SERVICE BULLETIN

N° **139-522**

**ATA 95 - INSTALLATION OF COCKPIT AND CABIN PASSENGER FLOOR BALLISTIC PROTECTIONS**

To provide all necessary instructions on how to perform the installation of the kit cockpit floor ballistic protection P/N 4G9580F00311, kit cockpit door ballistic protection P/N 4G9580F00411 and kit cabin passenger floor ballistic protection P/N 4G9580F00911.

**Figure 16**

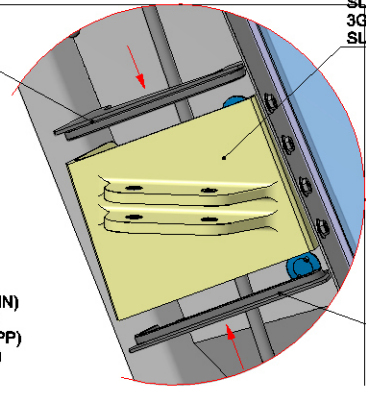
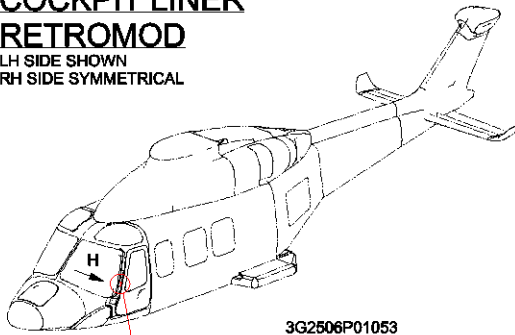
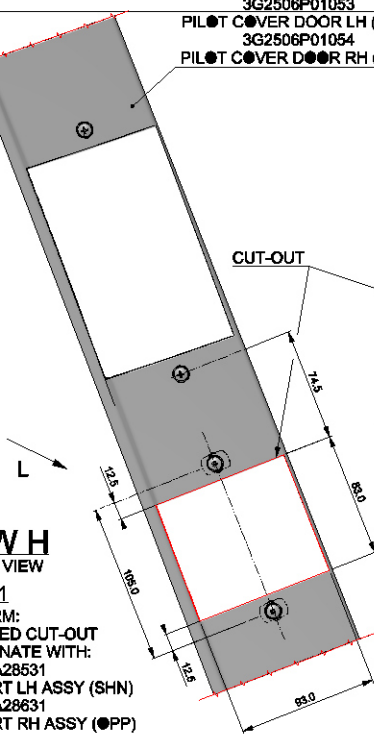
- 2.4.9 With reference to Figure 16 Detail EC (STEP 9), remove the lateral block P/N 3G9580A00451 and relevant hardware from the support assy LH P/N 3G5330A28531.

- 2.4.10 With reference to Figure 16 Detail EC (STEP 9), temporarily install the LH upper and lower covers P/N 3G5320A14251 and P/N 3G5320A14651 on the support assy LH P/N 3G5330A28531.

- 2.4.11 With reference to Figure 16 View H, perform indicated cut-out thru the pilot door cover LH; coordinate the cut-out position with the installed support assy LH P/N 3G5330A28531.

- 2.4.12 With reference to Figure 16 View L and Detail J, drill n°2 holes Ø5.0 thru pilot door cover LH in the indicated position coordinating with the holes on pilot cover LH P/N 3G5320A28531.

- 2.4.13 With reference to Figure 16 View L, bond n°2 nutplates P/N A407A3C2P on pilot door cover LH by means of EA9309.3NA adhesive.
- 2.4.14 With reference to Figure 16 View K, drill n°4 holes Ø4.52÷4.65 on pilot door cover LH coordinating with the holes on canopy.

Figure 17

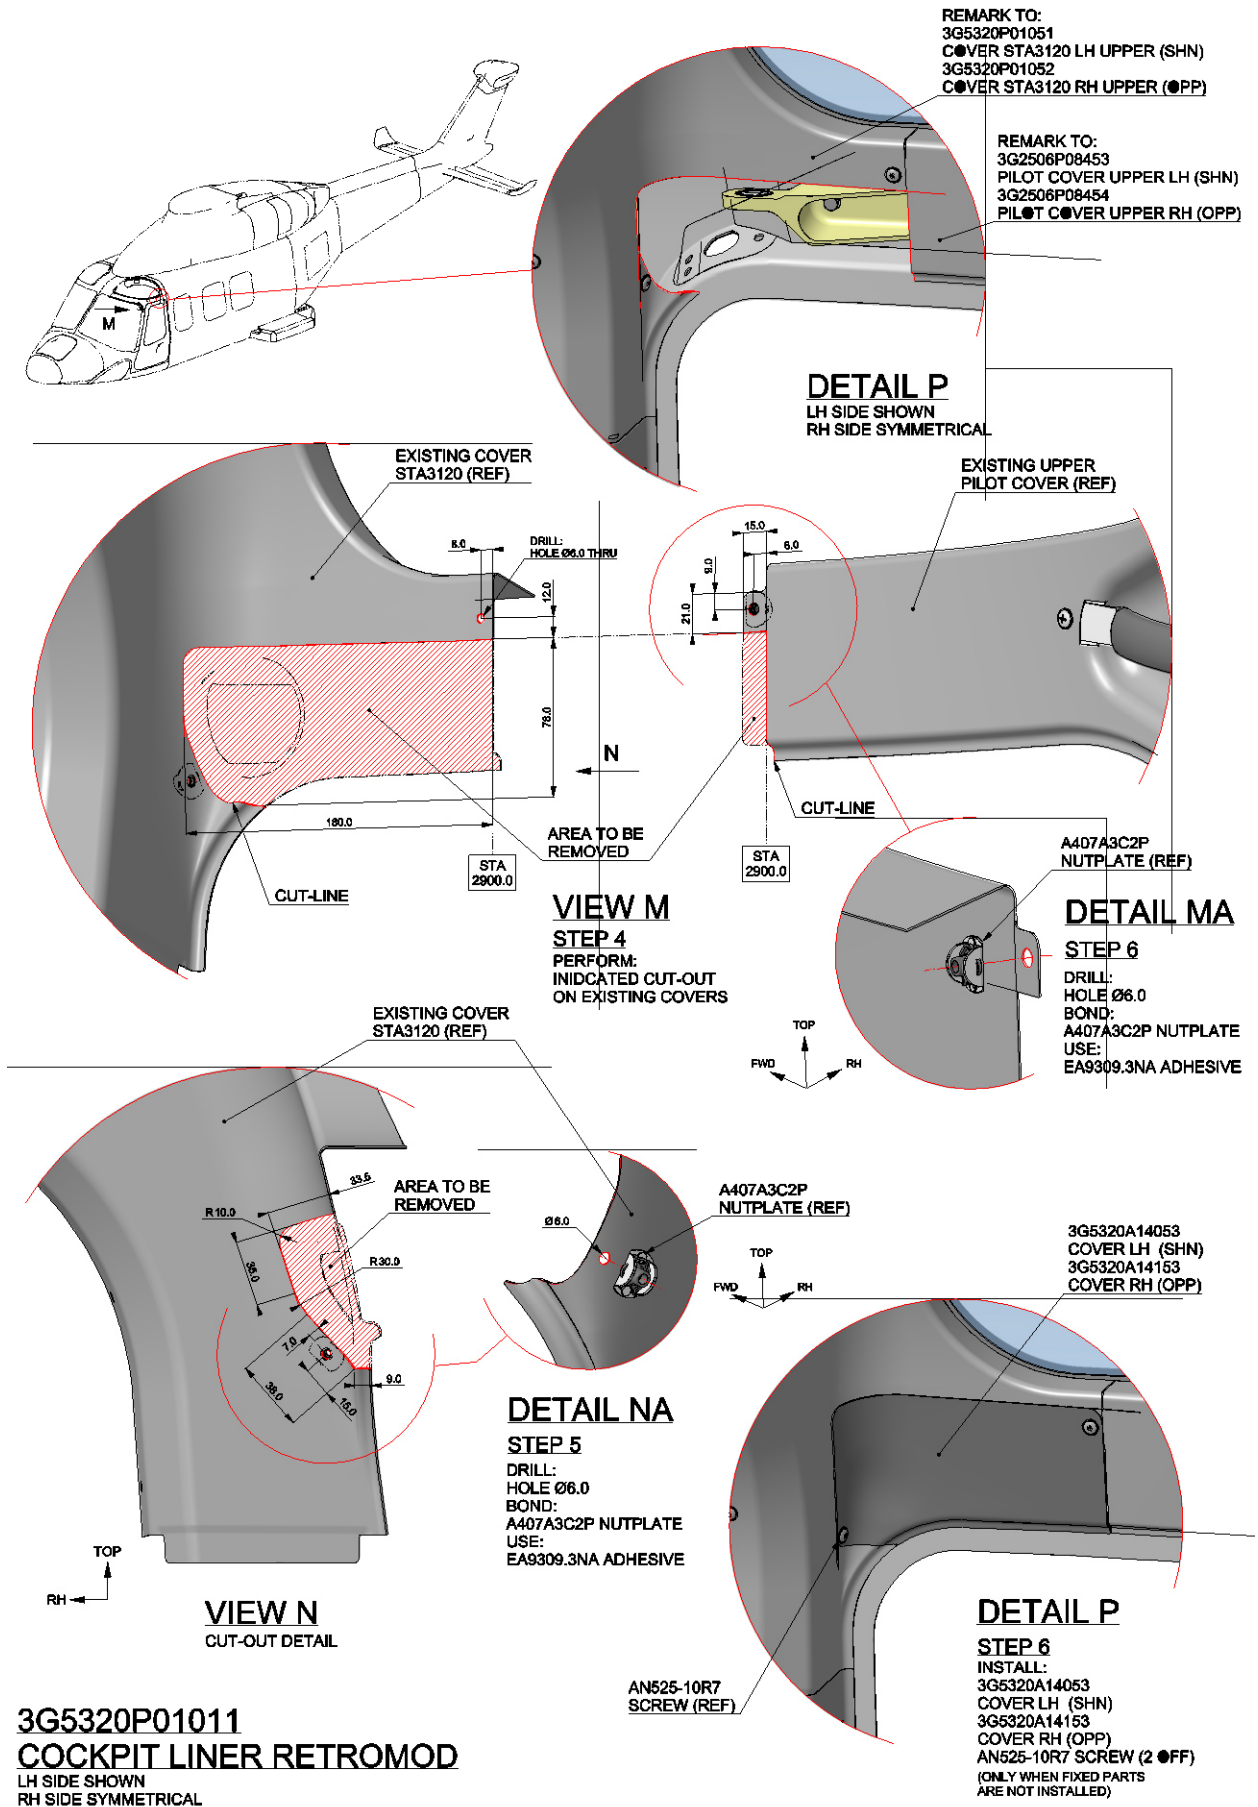
- 2.4.15 With reference to Figure 17 Views M and N, perform the indicated cut-out on the cover STA 3120.
- 2.4.16 With reference to Figure 17 Detail NA, drill an hole Ø5.0 thru cover STA 3120 and bond a nutplate P/N A407A3C2P by means of EA9309.3NA adhesive.

- 2.4.17 With reference to Figure 17 View M, perform the indicated cut-out on the existing upper pilot cover.
- 2.4.18 With reference to Figure 17 Detail MA, drill an hole Ø5.0 thru upper pilot cover and bond a nutplate P/N A407A3C2P by means of EA9309.3NA adhesive.

- 2.4.24 With reference to Figure 16 Detail J, install the pilot cover LH P/N 3G5330A13851 by means of n°2 screws P/N AN525-10R7.
  - 2.4.25 With reference to Figure 17 Detail P, install the cover LH P/N 3G5330A14053 by means of n°2 screws P/N AN525-10R7.

Figure 18

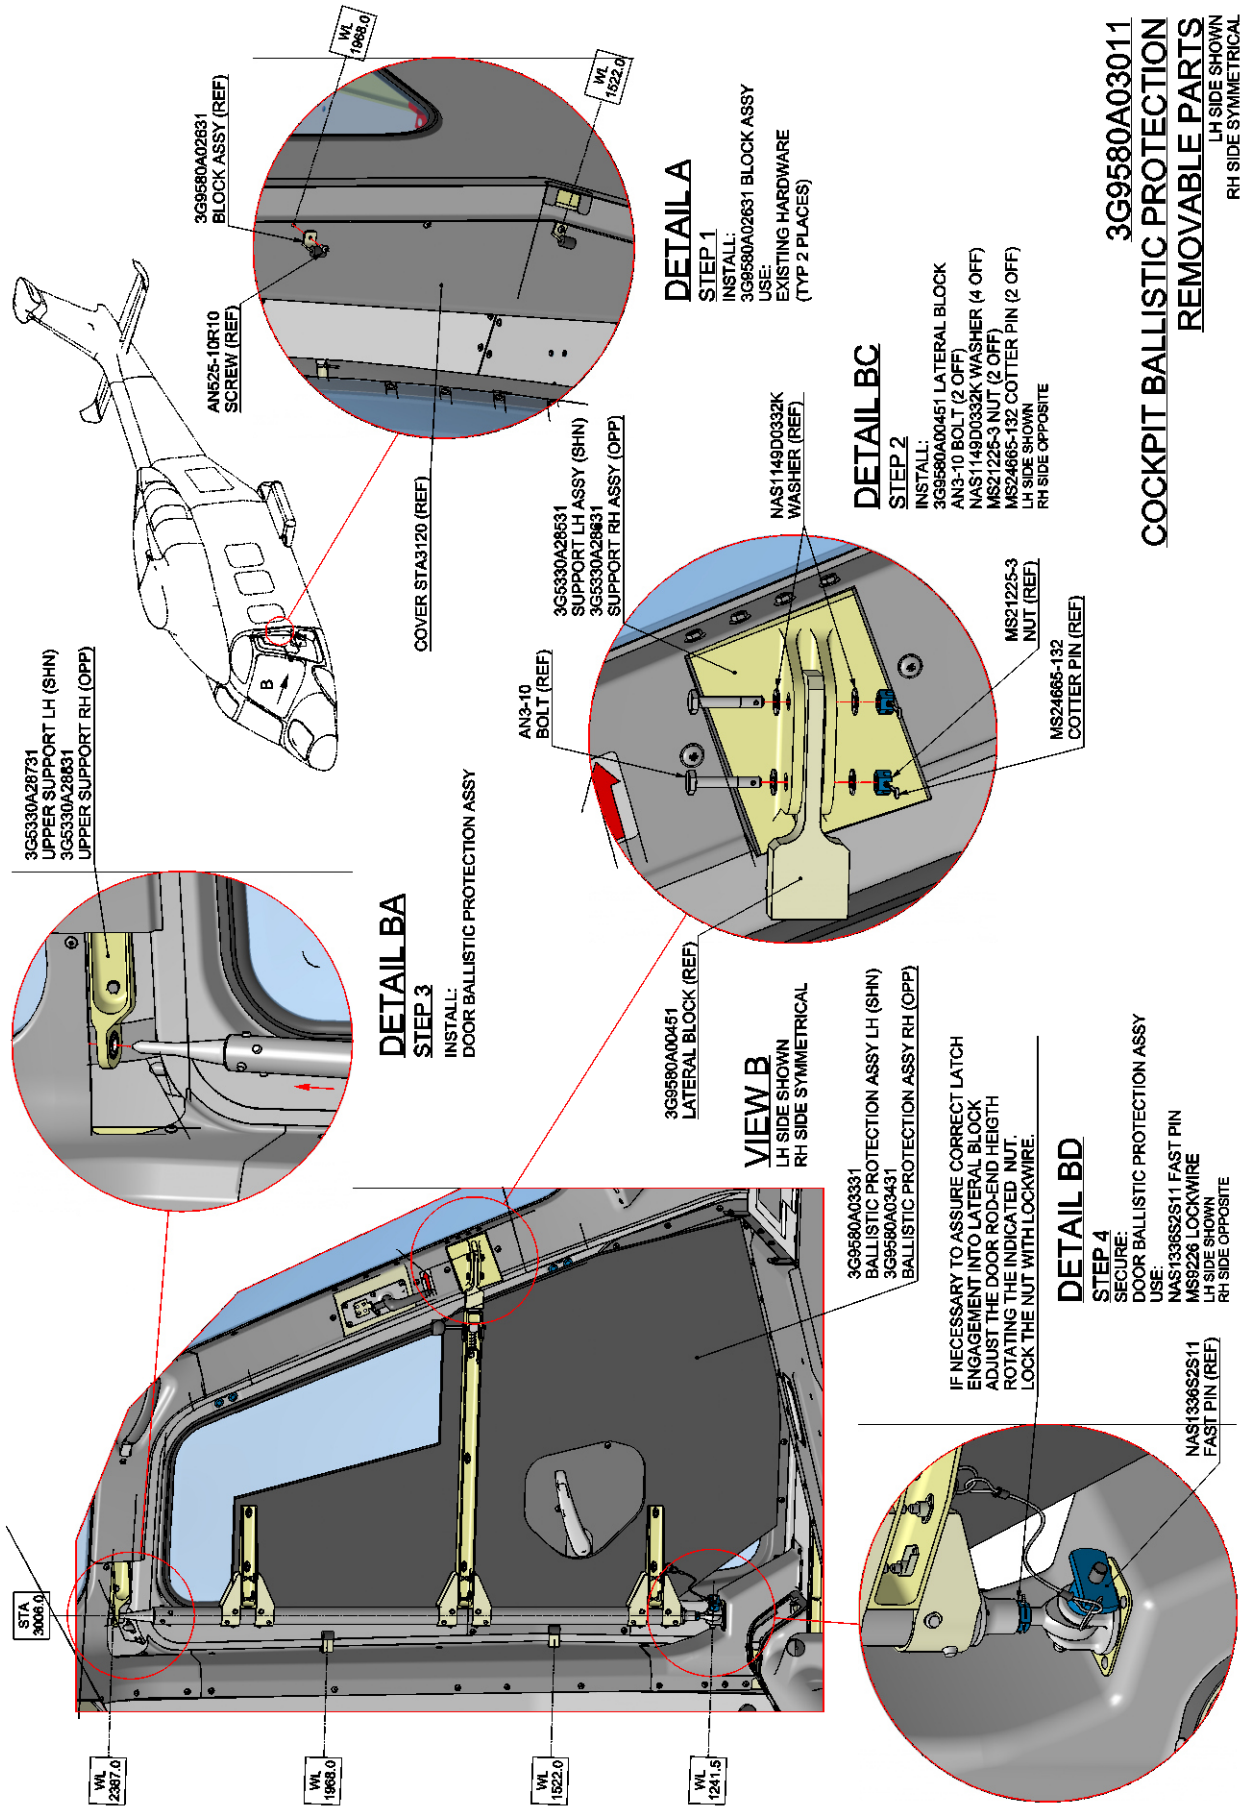
2. Perform the cockpit ballistic protection removable parts installation P/N 3G9580A03011 on LH side as described in the following procedure:
  - 2.1 With reference to Figure 18 Detail A, install n°2 block assy P/N 3G9580A02631 in the indicated position by means of existing hardware.

- 2.2 With reference to Figure 18 Detail BC, install the lateral block P/N 3G9580A00451 on the support assy LH P/N 3G5330A28531 by means of n°2 bolts P/N AN3-10, n°4 washers P/N NAS1149D0332K and n°2 nut P/N MS21225-3; lock the nuts by means of n°2 cotter pins P/N MS24665-132.

- 2.3 With reference to Figure 18 Details BA and BD, install the ballistic protection assy LH P/N 3G9580A03331 by means of fast pin P/N NAS1336S2S11.

- 2.4 With reference to Figure 18 Detail BD, if necessary to assure correct latch engagement into lateral block adjust the door rod-end height rotating the indicated nut. Lock the nut by means of lockwire.

**Figure 19**

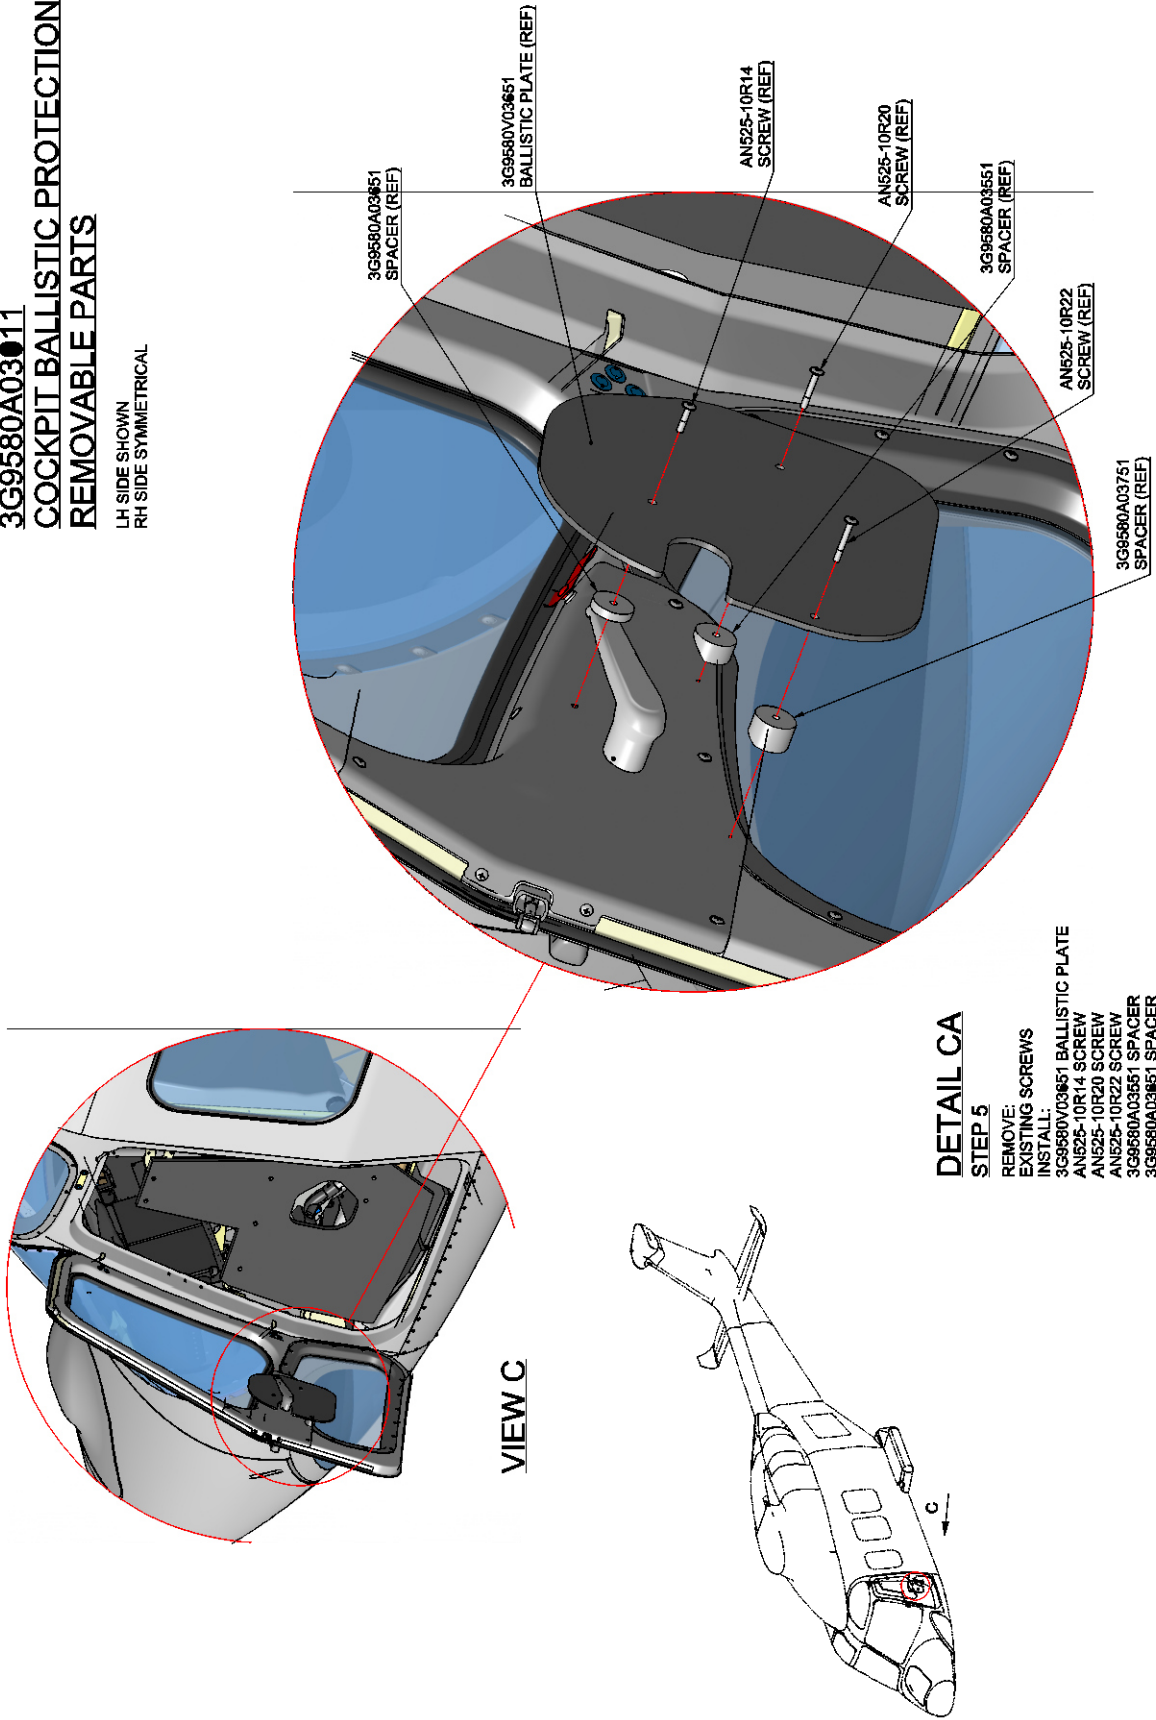
- 2.5 With reference to Figure 19 Detail CA, remove the indicated screws and install ballistic plate P/N 3G9580V03651, a spacer P/N 3G9580A03551, a spacer P/N 3G9580A03651 and a spacer P/N 3G9580A03751 by means of a screw P/N AN525-10R20, P/N AN525-10R140 and a screw P/N AN525-10R20.

Figure 21

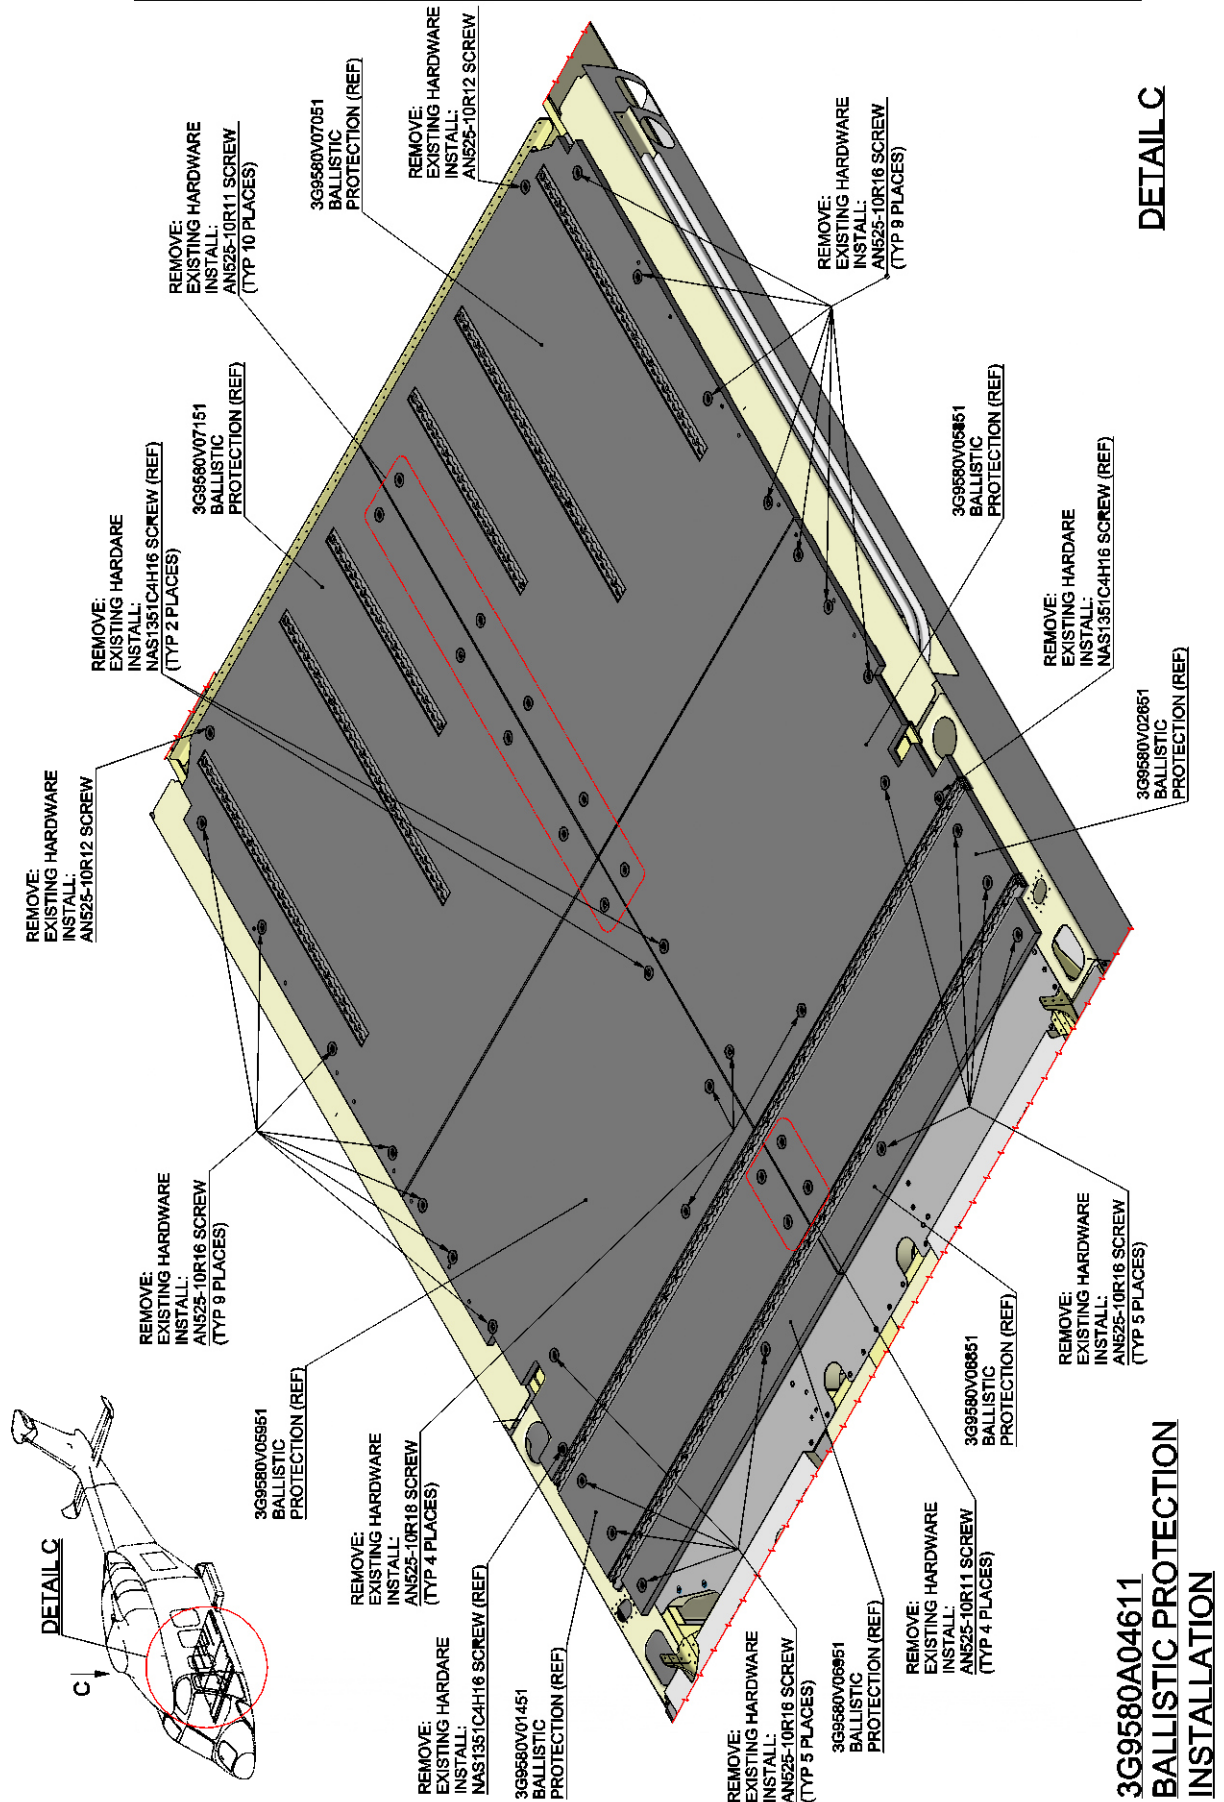
- 2.1 With reference to Figure 21 Detail A, temporarily position all the following ballistic protections on the floor:
    - 3G9580V01451
    - 3G9580V02651

- 3G9580V05851
    - 3G9580V05951
    - 3G9580V06851
    - 3G9580V06951
    - 3G9580V07051
    - 3G9580V07151
  - 2.2 With reference to Figure 21 Detail A and View C, countermark the indicated n°16 hole positions on relevant floor panels.

- 2.3 With reference to Figure 21 View C and Section B-B, drill n°16 holes Ø14.25±14.38 in the countermarked positions and install n°16 inserts P/N NAS1832-3-4 by means of EA934NA adhesive.
